ADDENDUM NUMBER ONE

DATE: March 28, 2019

PROJECT: City of Myrtle
Renovations to 13th Ave. South for Facilities Maintenance

A1.0

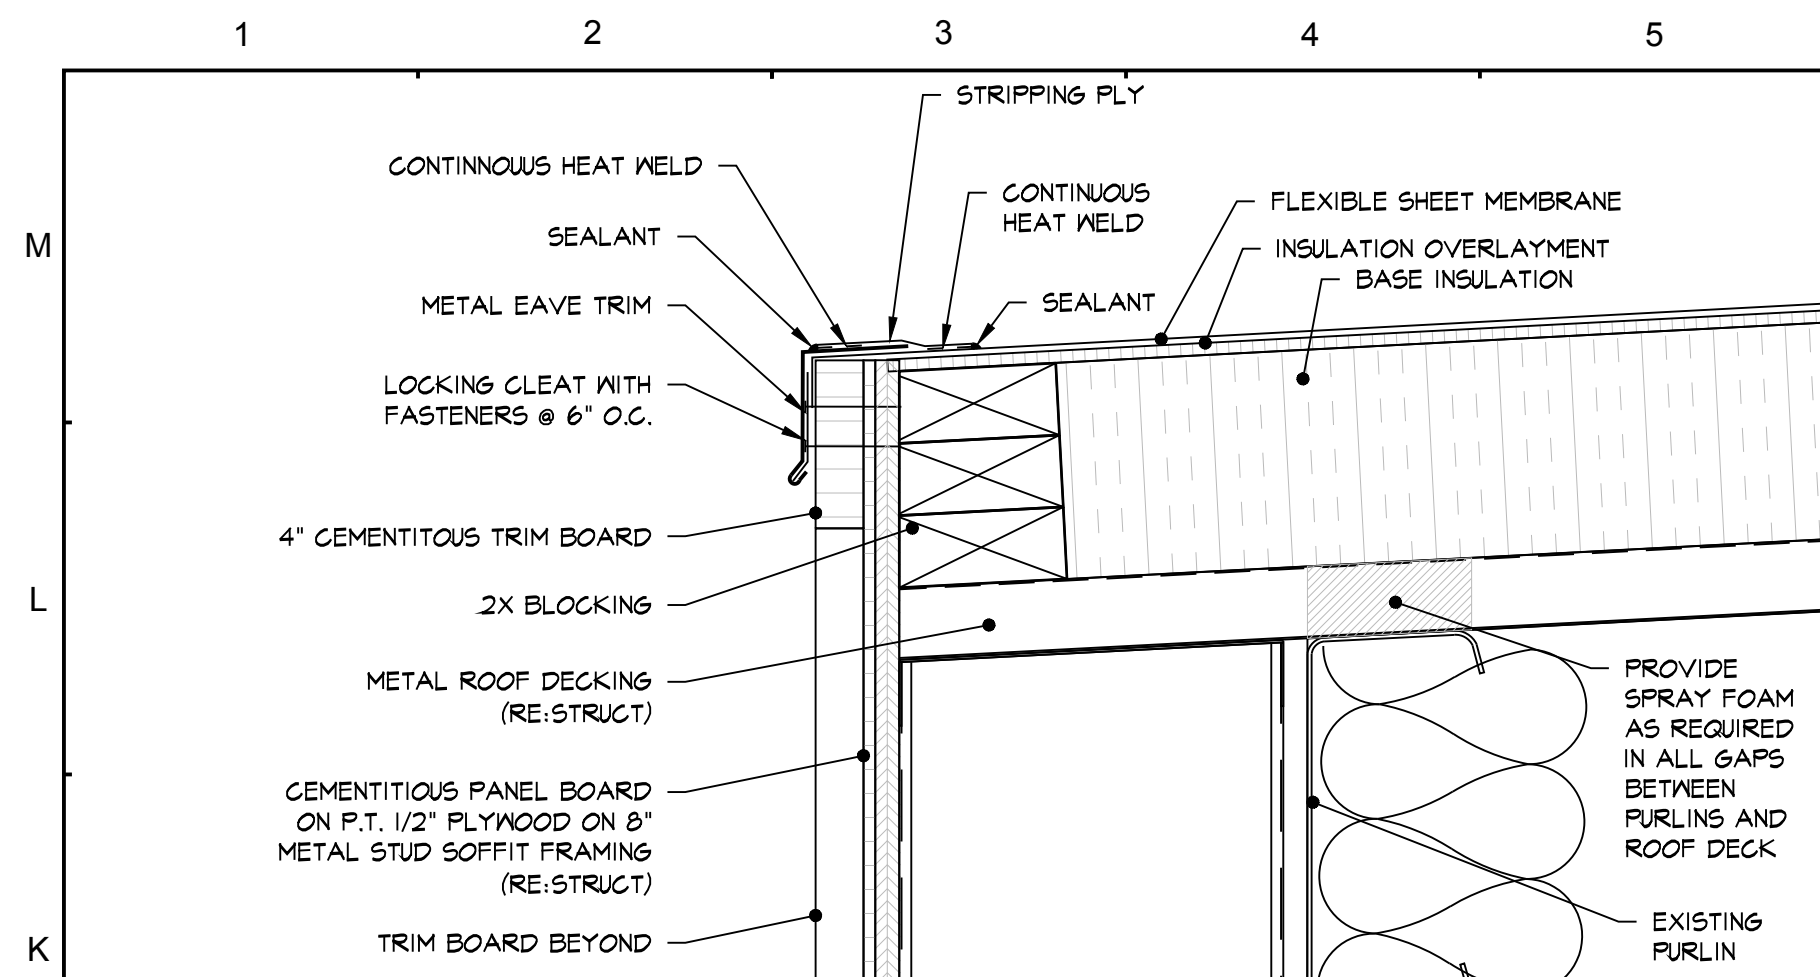
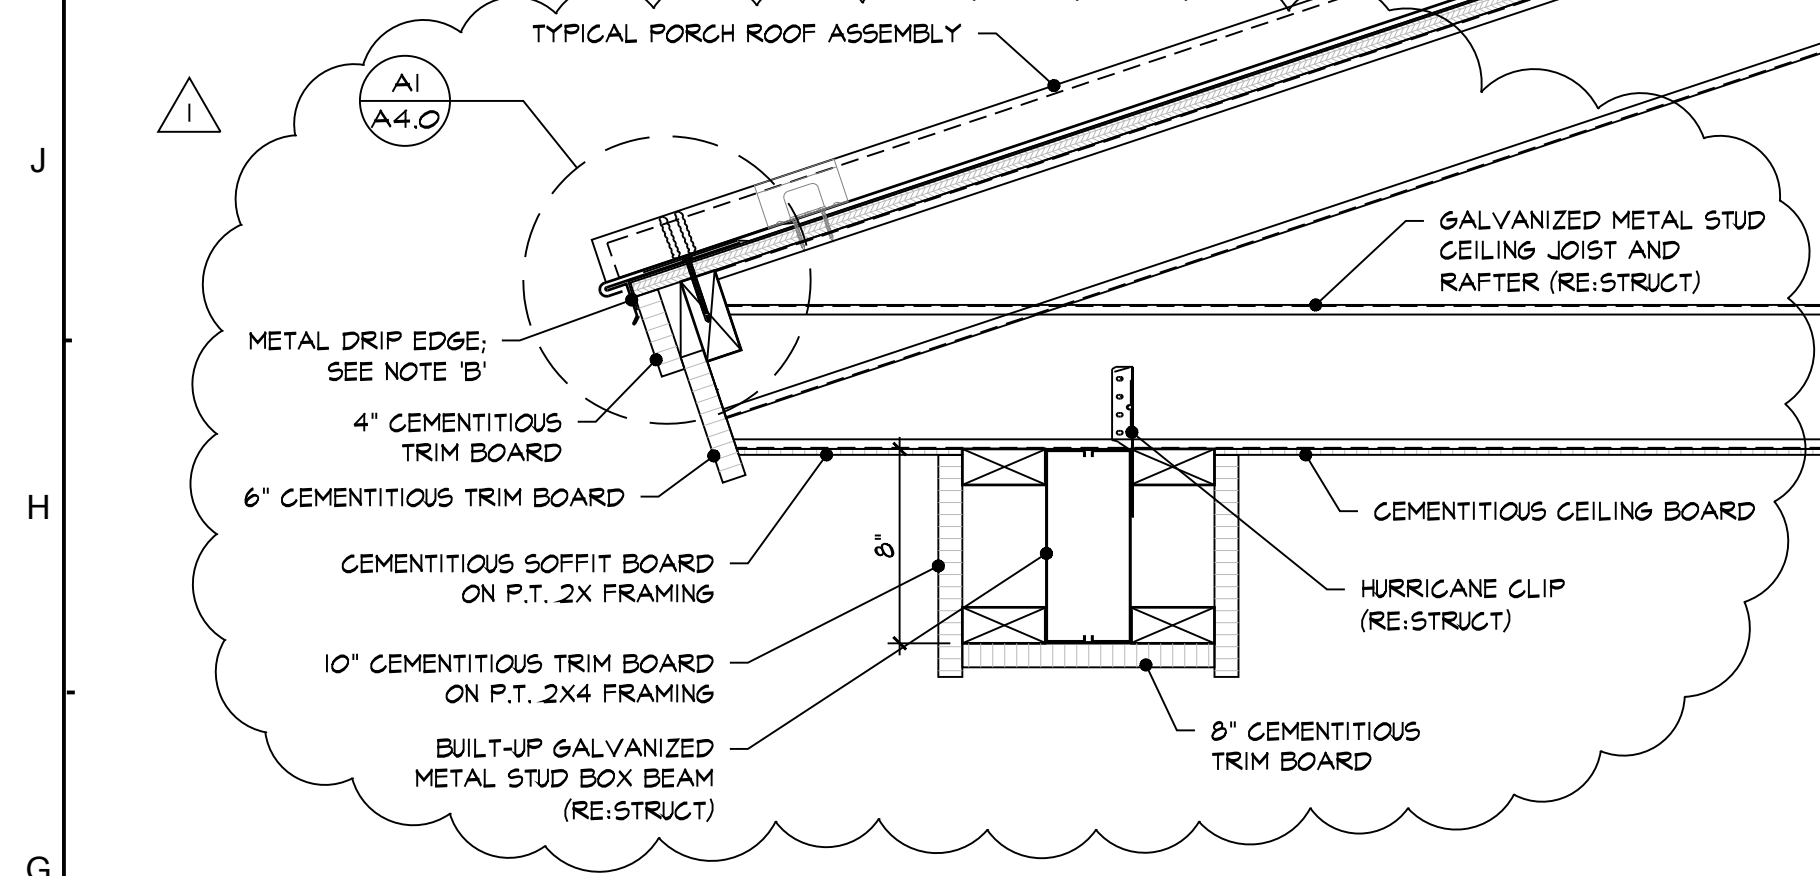
Refer to revision bubbles for deletion of urinal symbol in Toilet 106, deletion of reference to ships ladder in Workshop 121, deletion of any reference to attic storage and any associated framing, modification of framing for Porches 100 and 120 and General Note S.
